File No. 2320.38.032

October 15, 2024

Re: Kenai Gas Field 2023 Groundwater Monitoring Program Report

ADEC Comments - Pad 41-7

Kenai Gas Field 41-7 Groundwater Elevation Potential - Pad to Mineral Soils

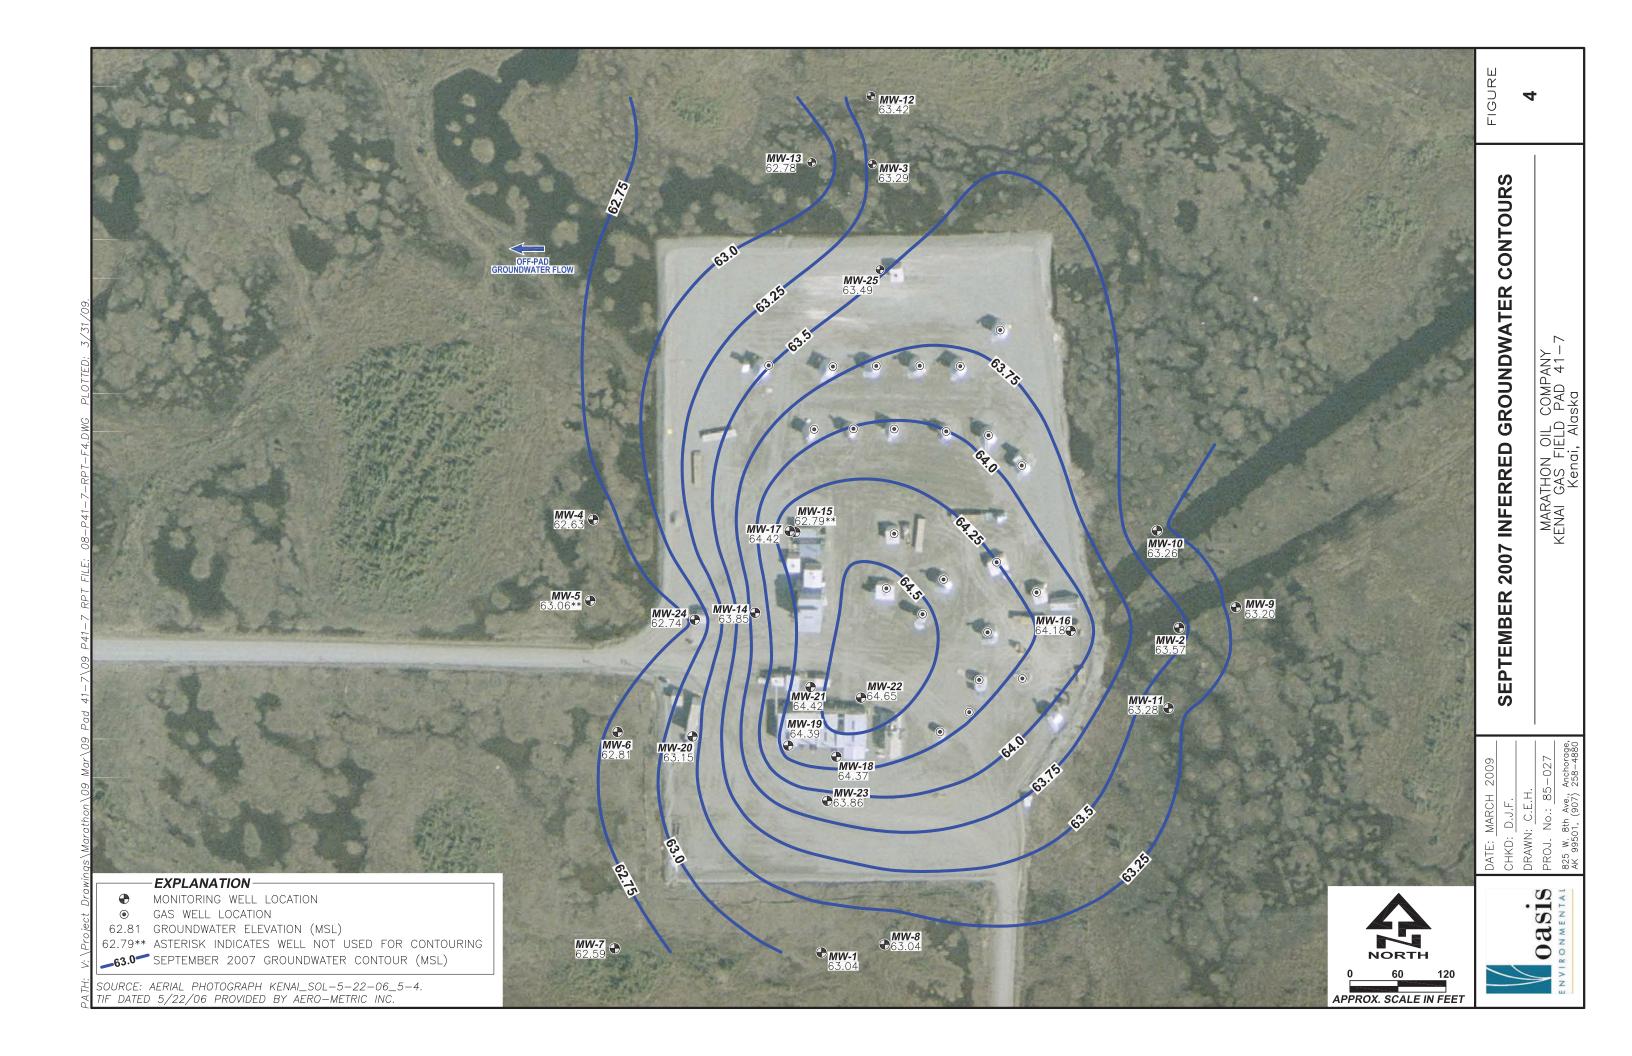
This is demonstrated by the groundwater elevations in monitoring wells MW-15 and MW-17 in the central pad, where there is a downward potential from the pad groundwater into the underlying mineral soils "aquifer". MW-15 is screened with a two-foot screen in the mineral soils from 15 to 17 feet below ground surface. MW-17 is screened in the pad soils and into the peat soils from two to 12 feet below ground surface.

The attached table shows representative groundwater elevations in the two monitoring wells from 2007 to 2010. The majority of the groundwater elevations demonstrate downward groundwater potential from the pad to the mineral soils. There are seasonal and other precipitation events that may influence wells screened in the mineral soils and wells close to the peat / mineral soil interface that then show an upward potential.

It is our understanding from these two wells and other well observations represent conditions on the pad in general. The concern is that contamination within the pad may be migrating through wells that are screened through pad contamination and through the peat layer or at the bottom of the peat layer,

where the potentiometric head may be carrying dissolved phase contamination into a previously unimpacted zone. The two 2007 Groundwater Contour Maps attached demonstrate the potential for downward groundwater movement.

Hilcorp should evaluate their monitoring network and determine which wells are set into the peat and have the potential of leaking from the peat into the lower aquifer. It is our opinion that these wells should be abandoned by injecting liquid grout that is tremmied into the casing after the screen plug is knocked out to ensure a competent well borehole seal. The casing should not be removed until grouting is started, i.e. no open borehole grouting.

A monitoring network should then be established that has wells set in the upper pad soils and separately in the lower mineral soils to monitor for impacts that have or may be occurring in the lower "aquifer". The peat should be considered an organic aquitard, and not be penetrated if possible.
